RE: 29 Bowdoin Street
Portland, Maine

I have been asked by Mr. Curtis Dow of Cordjia to review a few items of concern you had at the referenced project. I visited the project on June 28 and reviewed most items but had to return today to review a few items that needed access.

SKS-02

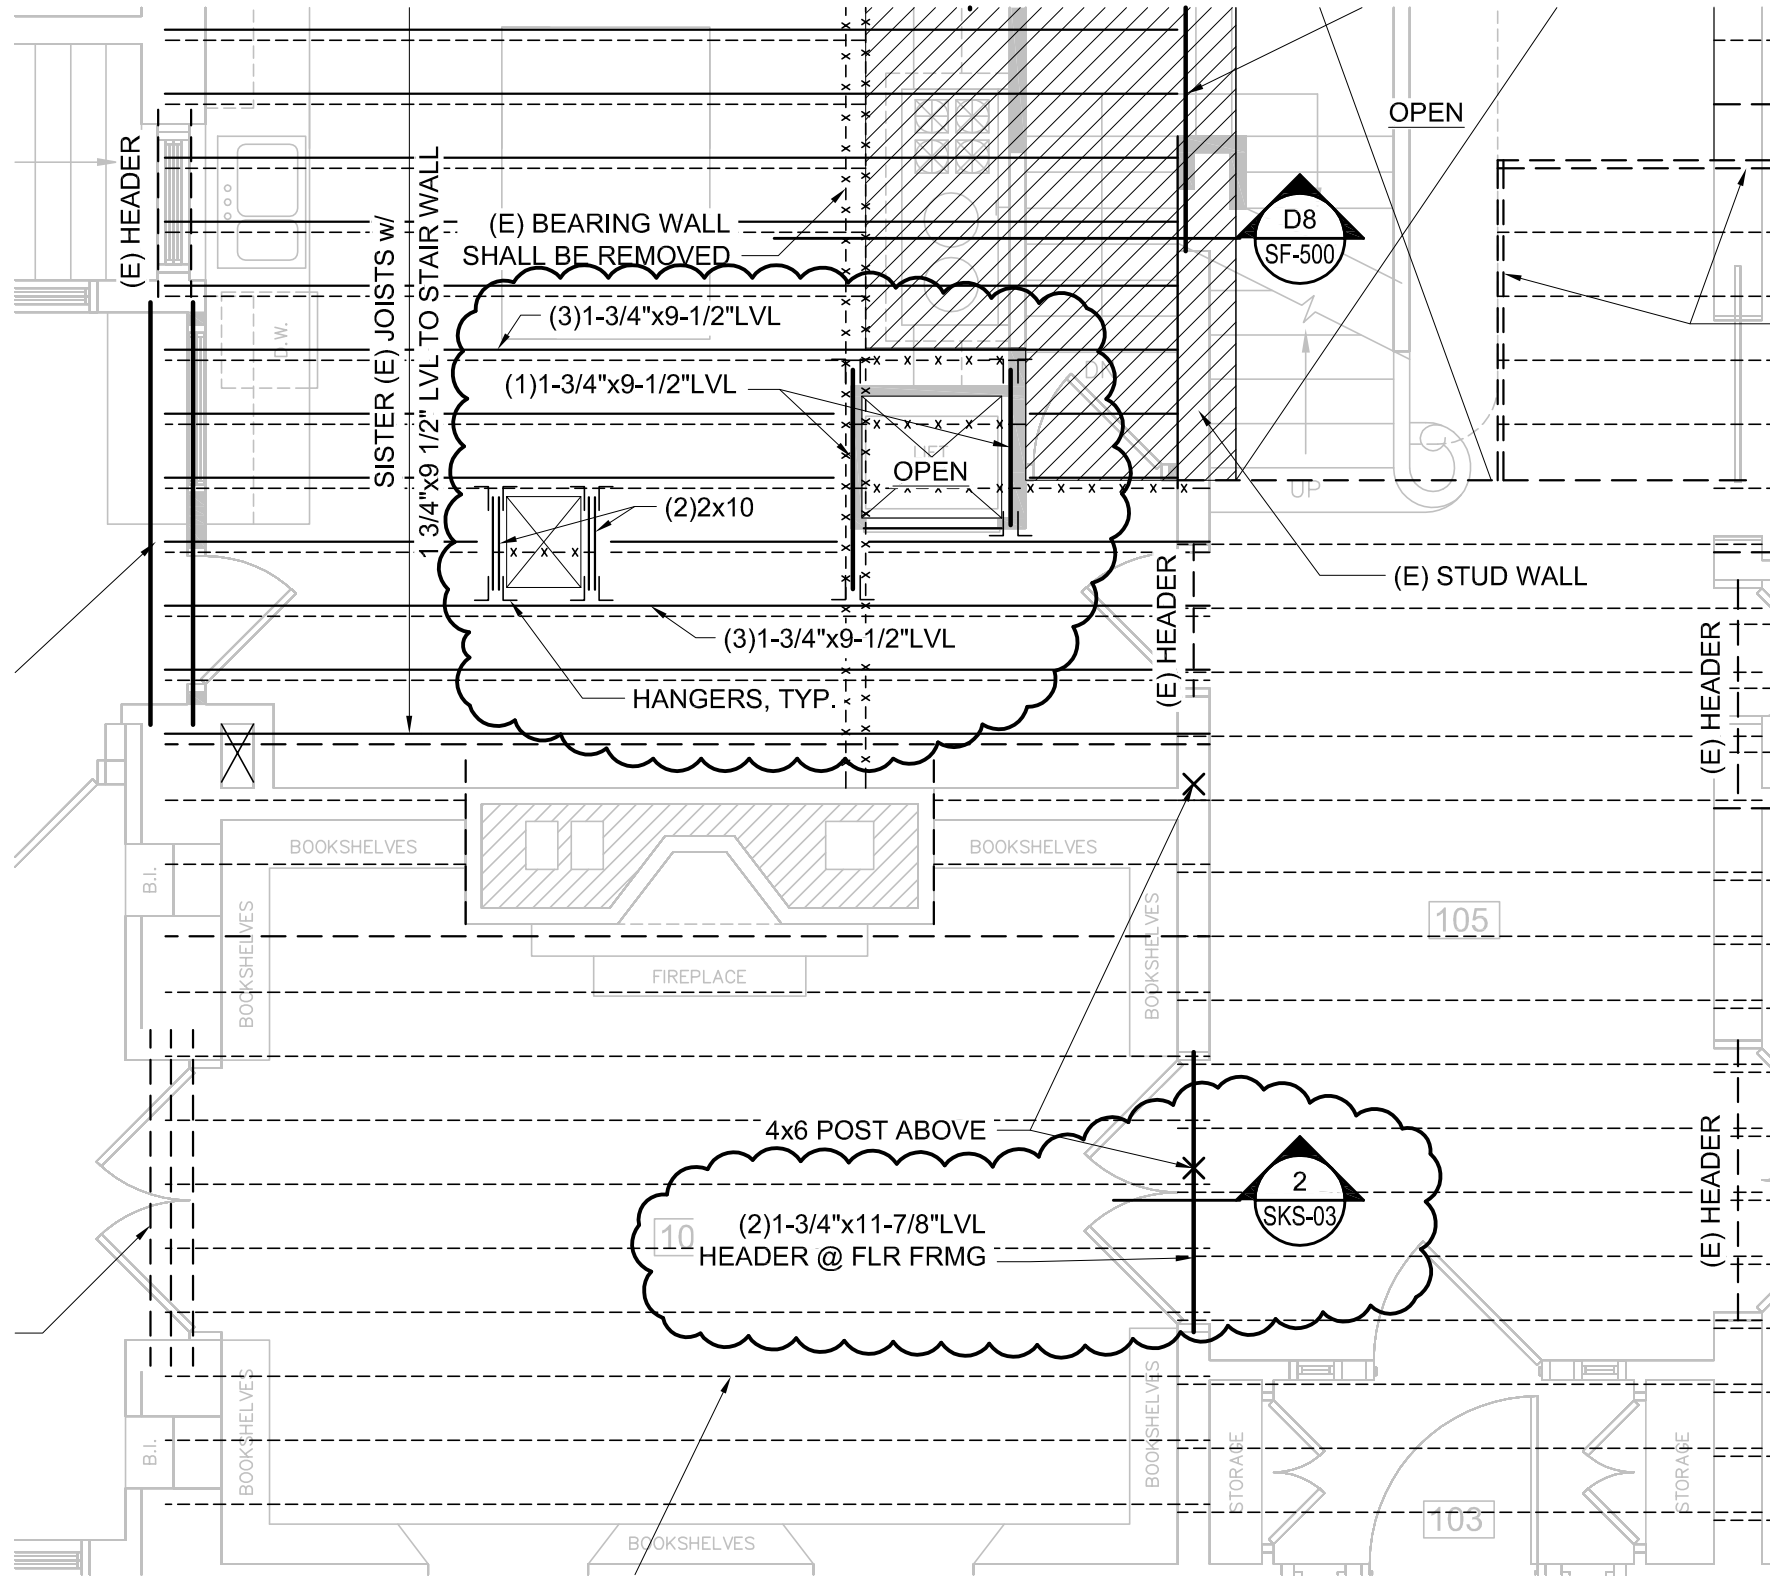
2. Second Floor Shaft Opening Header: The second floor framing above the kitchen has two openings with headers and was not completed as detailed (see attached sketch SKS-02). My solution is to turn the wood stud shaft wall into a supporting wall by adding one more 2 x 4 stud sistered to the existing stud at both the basement and first floor level. This will satisfy the small load on this wall.
